## **ADDENDUM #2**

Citrus Grove Road Phase 2  
Project No. 2025-04, Bid No. 25-749

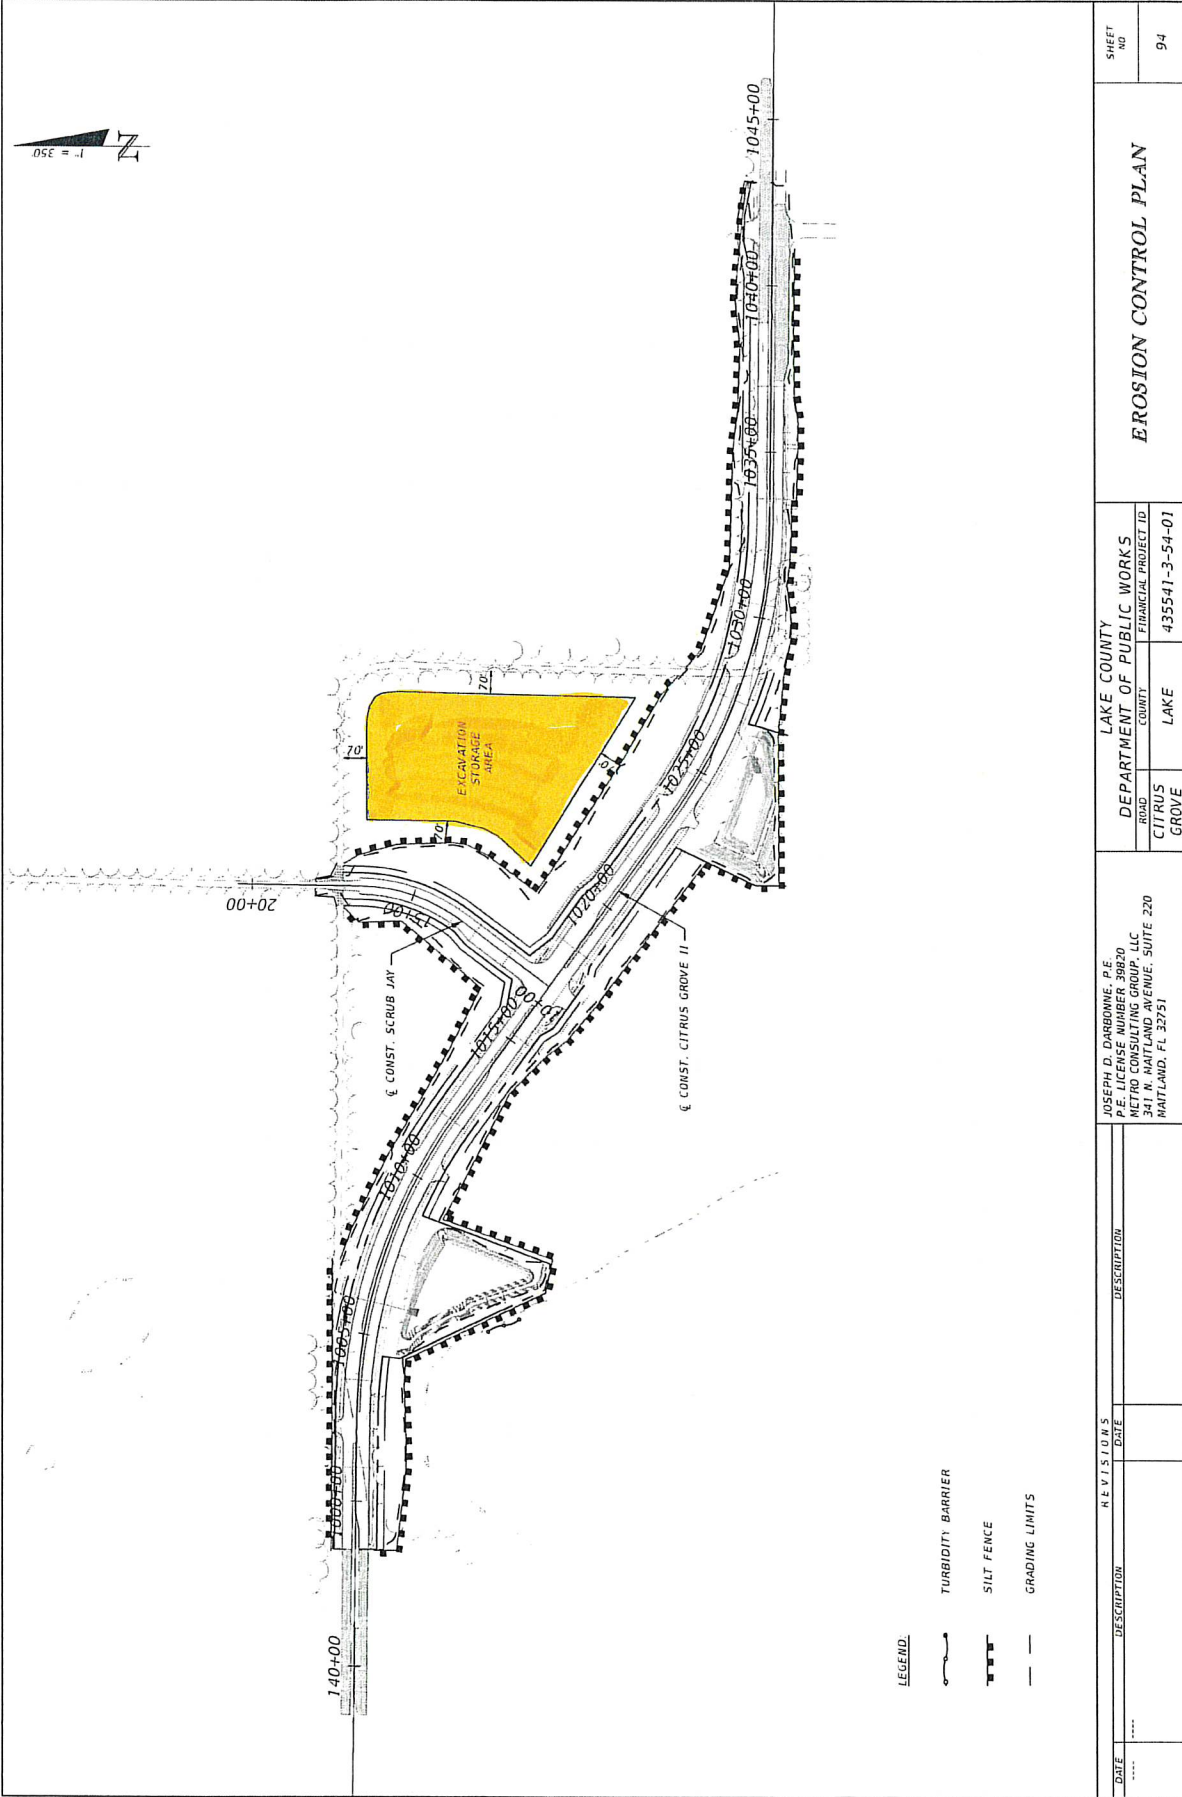
**Q3:** Drawing sheet 94 references an area labeled "excavation storage area". Please clarify the intent of this designated area. Is it the Owner's intent that the excess excavated material is stored here and becomes the property of the Owner?

**Q4:** If the intent of this excavation storage area is to stockpile material for the Owner, please consider a larger area as the quantity to stockpile will be fairly high and difficult to maintain.

**A4:** Contractor shall safely, and securely stockpile excess material on site as shown in the attached aerial to be used by the developer at a later date.
